5020 N. INTERSTATE

APPLICANT APPEAL 1

NEIGHBORHOOD APPEAL

CHAIN LINK FENCE PARTIAL ELEVATION - APPLICANT PROPOSAL

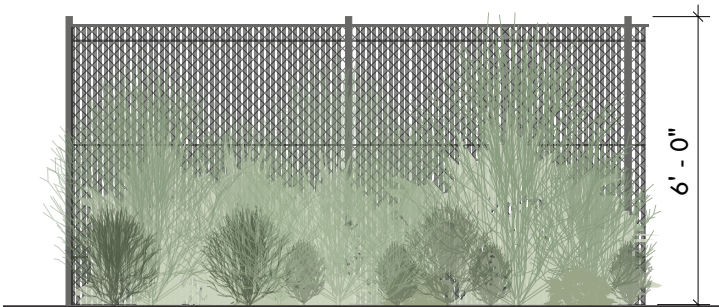
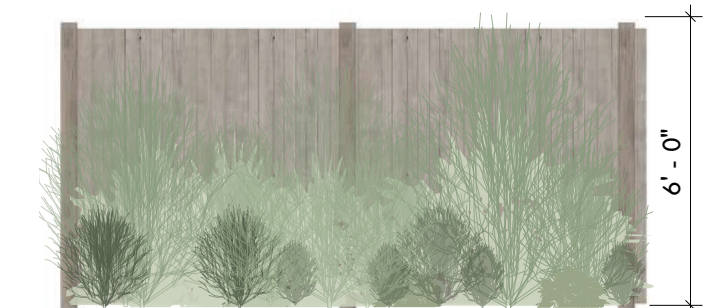
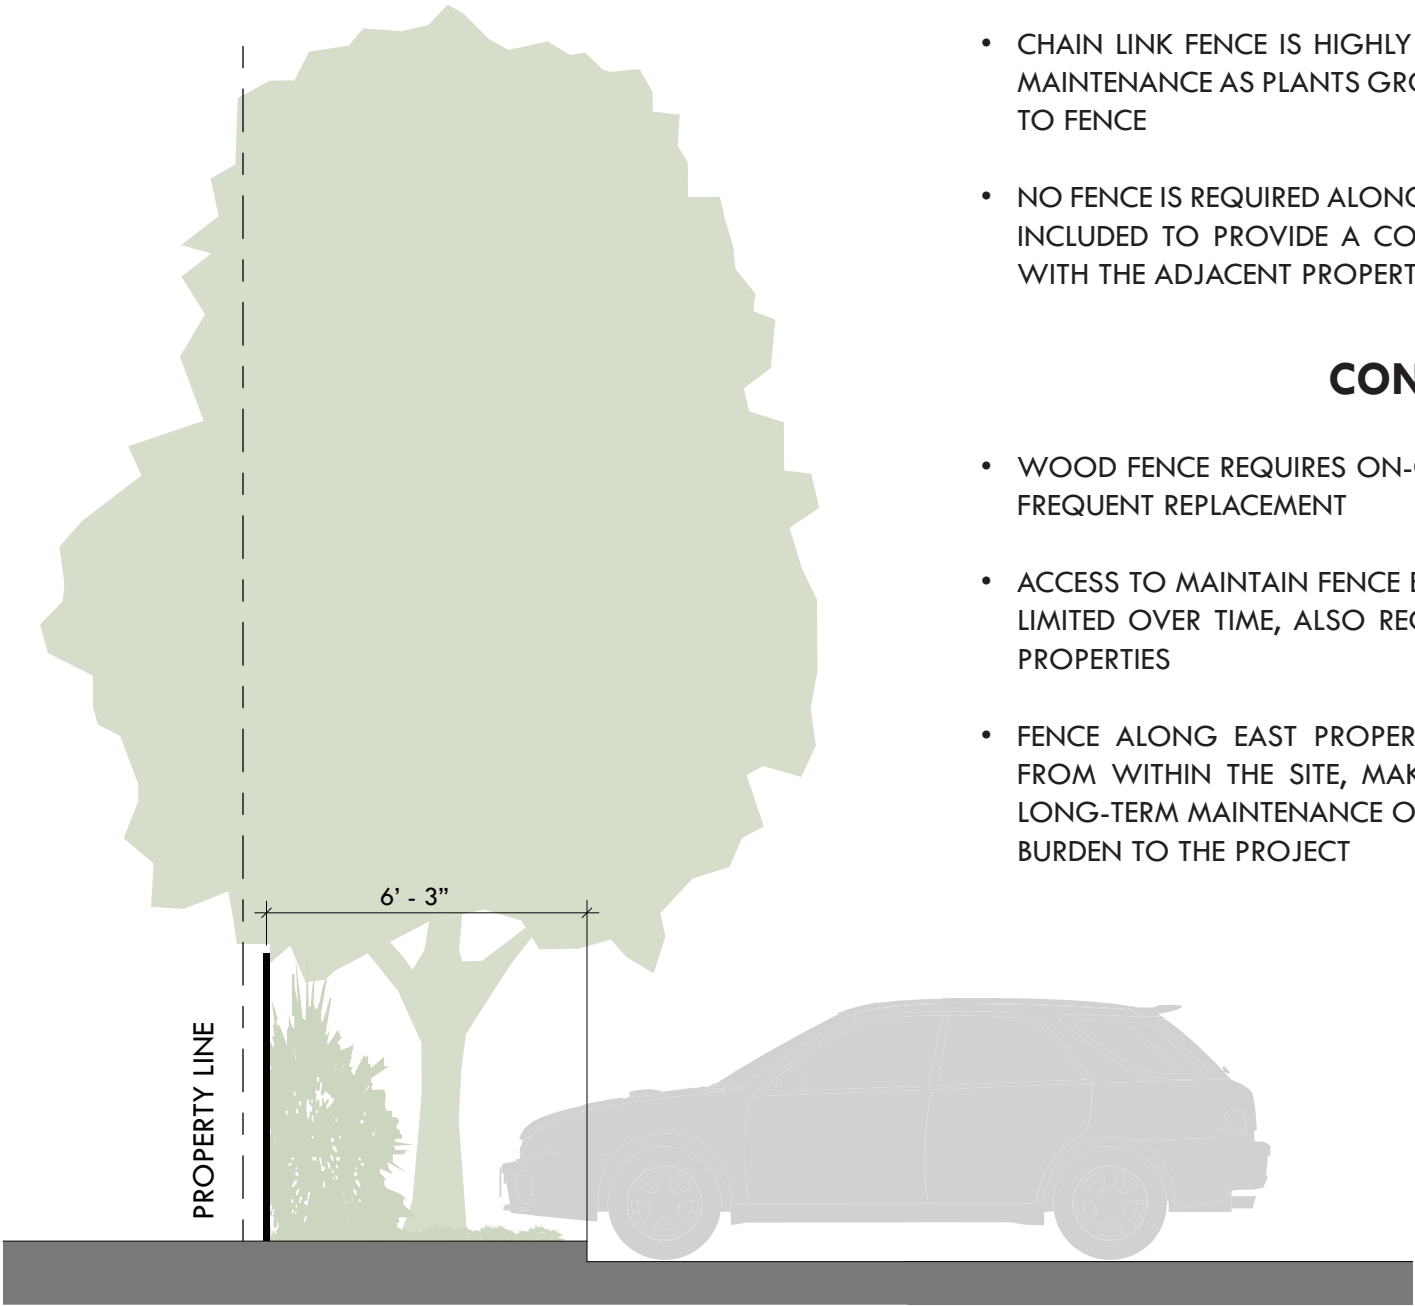
CONDITION OF APPROVAL 5

“THE PROPOSED CHAIN-LINK FENCE SHALL BE REPLACED WITH THE ORIGINALLY-PROPOSED, SIGHT OBSCURING WOOD FENCE (AS SHOWN IN EXHIBIT C.48).”

- PROVIDE BLACK COATED CHAIN LINK FENCE WITH BLACK PRIVACY SLATS AS BACK DROP TO EVERGREEN SHRUB PLANTINGS
- SELECTED EVERGREEN SHRUB, TALL OREGON GRAPE (MAHANIA AQUIFOLIUM), WILL PROVIDE ADDITIONAL CONTINUOUS SCREENING OF PARKING FROM ADJACENT PROPERTIES AND WILL EVENTUALLY OBSCURE SIGHT OF THE FENCE FROM WITHIN THE PROPERTY AS IT GROWS BETWEEN 4' AND 10' TALL
- CHAIN LINK FENCE IS HIGHLY DURABLE AND WILL NOT REQUIRE MAINTENANCE AS PLANTS GROW AND EVENTUALLY LIMIT ACCESS TO FENCE
- NO FENCE IS REQUIRED ALONG THE EAST BOUNDARY; IT HAS BEEN INCLUDED TO PROVIDE A CONTINUOUS, SECURE EDGE SHARED WITH THE ADJACENT PROPERTIES

- WOOD FENCE REQUIRES ON-GOING MAINTENANCE AND MORE FREQUENT REPLACEMENT
- ACCESS TO MAINTAIN FENCE BORDERED BY TALL SHRUBS WILL BE LIMITED OVER TIME, ALSO REQUIRES ACCESS TO NEIGHBORING PROPERTIES
- FENCE ALONG EAST PROPERTY LINE IS MOSTLY VISIBLE ONLY FROM WITHIN THE SITE, MAKING THE ADDITIONAL COST AND LONG-TERM MAINTENANCE OF WOOD FENCE AN UNNECESSARY BURDEN TO THE PROJECT

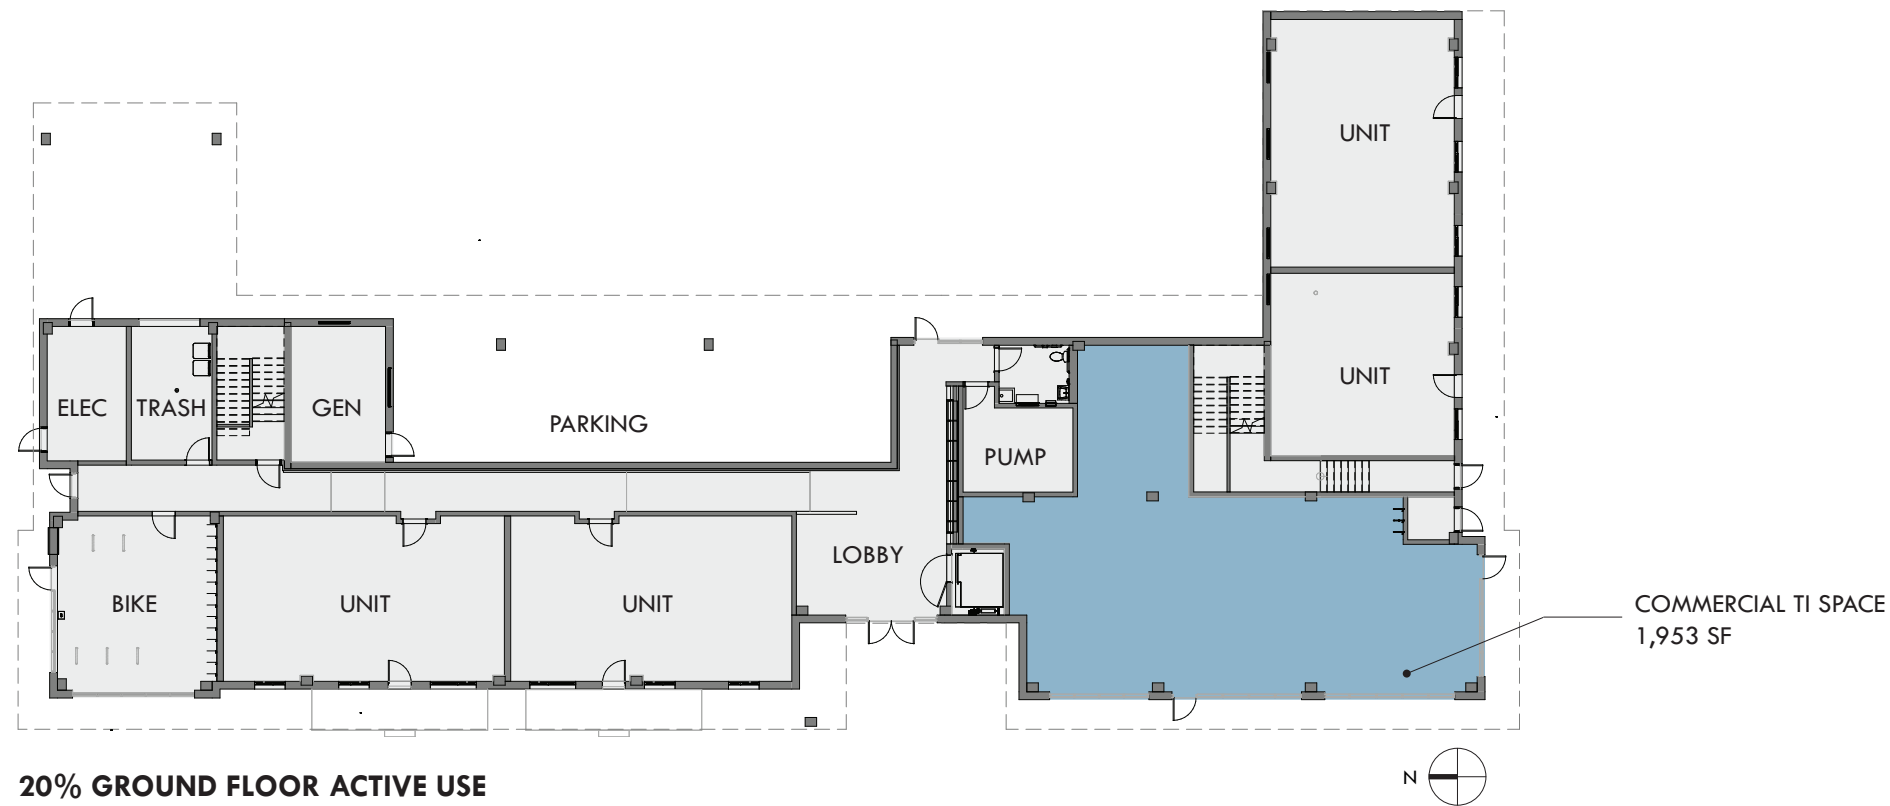
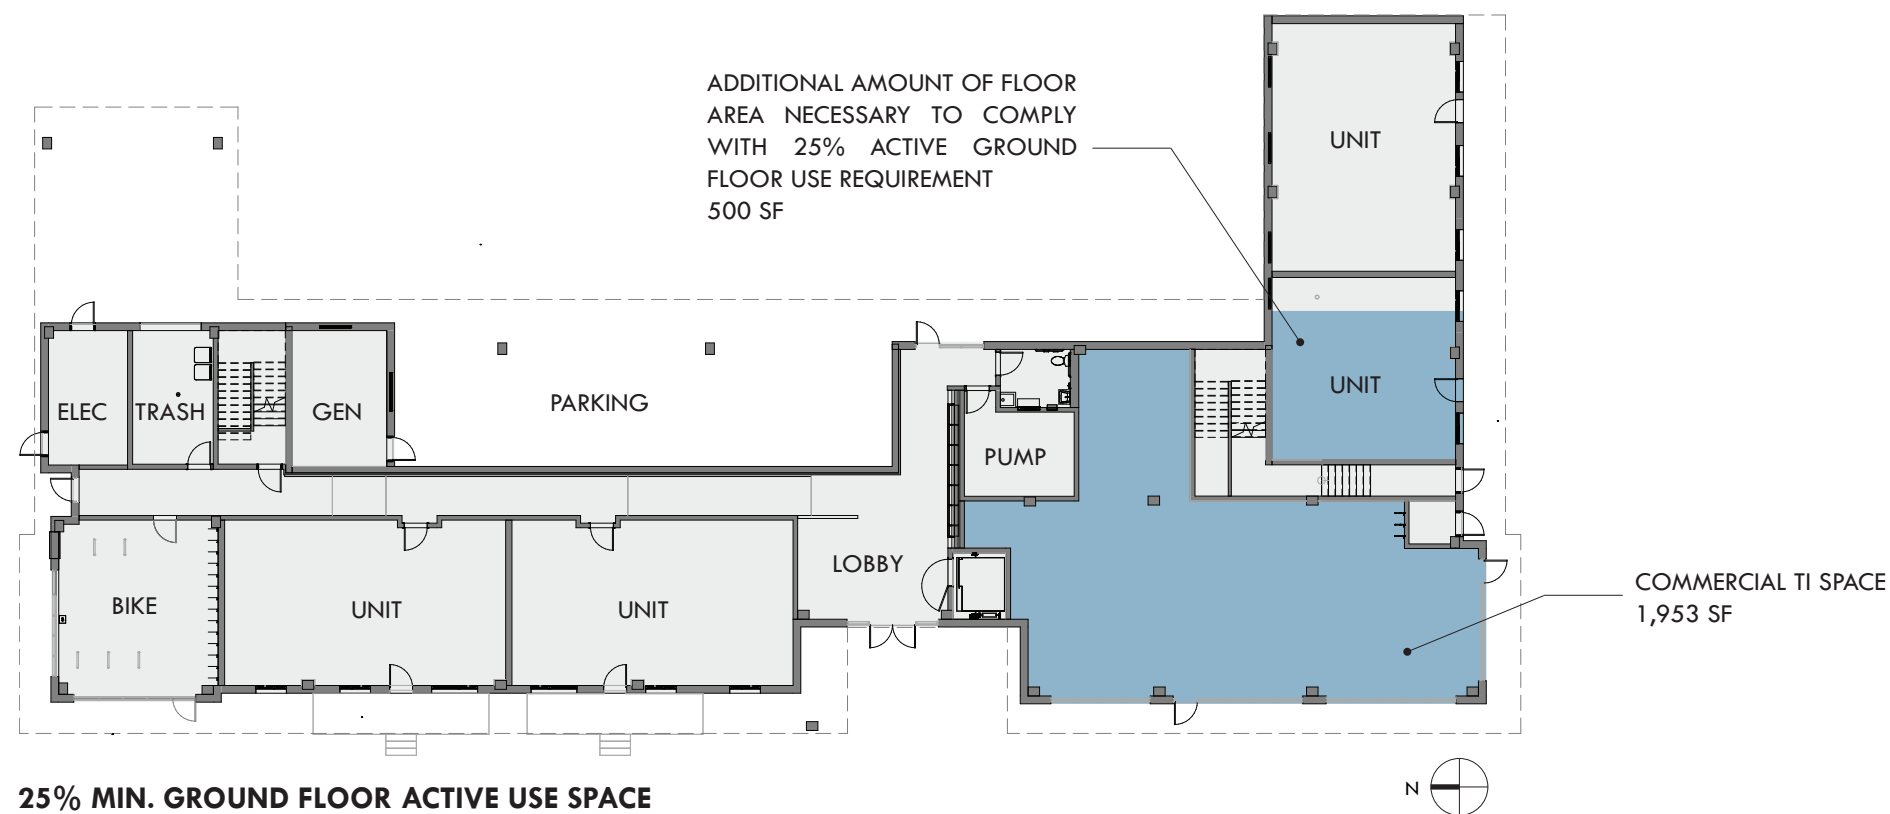
THE OVERLOOK NEIGHBORHOOD ASSOCIATION HAS APPEALED THE ADMINISTRATIVE DECISION TO THE APPROVED ADJUSTMENT REQUEST TO THE ZONING CODE DEVELOPMENT STANDARDS:

“33.415.200 - REQUIRED GROUND FLOOR ACTIVE USE: TO REDUCE THE AMOUNT OF REQUIREMENT GROUND FLOOR ACTIVE USE AREA WITHIN 100 FT OF A TRANSIT STREET - WHICH N. INTERSTATE AVE. AND N. ALBERTA ST. ARE - FROM 25% TO AT LEAST 19.5% OF THE TOTAL GROUND FLOOR AREA.”

- MEET THE REQUIREMENT OF THE “M” OVERLAY ZONE WITH AT LEAST 25% OF THE BUILDING GROUND FLOOR AREA DEDICATED TO A QUALIFIED ACTIVE USE AS LISTED PER SEC. 33.415.200 OF THE ZONING CODE:
 - RETAIL SALES AND SERVICE;
 - OFFICE;
 - INDUSTRIAL SERVICE;
 - MANUFACTURING AND PRODUCTION;
 - COMMUNITY SERVICE;
 - DAYCARE;
 - RELIGIOUS INSTITUTIONS;
 - SCHOOLS;
 - COLLEGES;
 - MEDICAL CENTERS
- CONVERTING THE BIKE ROOM AT THE NW CORNER AS REQUIRED BY CONDITION OF APPROVAL WILL ONLY WORK IF THE BIKE ROOM CAN MOVE TO ANOTHER GROUND FLOOR LOCATION. LIMITED SPACE IN FAMILY SIZED UNITS DOES NOT ALLOW FOR IN-UNIT BIKE PARKING

- MEET THE INTENT OF THE “M” OVERLAY ZONE TO PROVIDE CONTINUOUS AREA OF SHOPS AND SERVICES WITH 20% OF THE GROUND FLOOR AREA DEDICATED TO FUTURE OFFICE/RETAIL SALES AND SERVICES SPACE
- MEET THE INTENT OF THE “M” OVERLAY ZONE TO BE SUPPORTIVE OF TRANSIT BY PROVIDING BIKE ROOMS AND BIKE MAINTENANCE AMENITIES IN THE BUILDING AND A COMFORTABLE SIDEWALK ENVIRONMENT AT THE STREET LEVEL FOR PEDESTRIANS WITH WIDE SIDEWALKS, BUILDING OVERHANGS THAT COVER THE PEDESTRIAN PATH, LANDSCAPE PLANTERS AND BENCHES
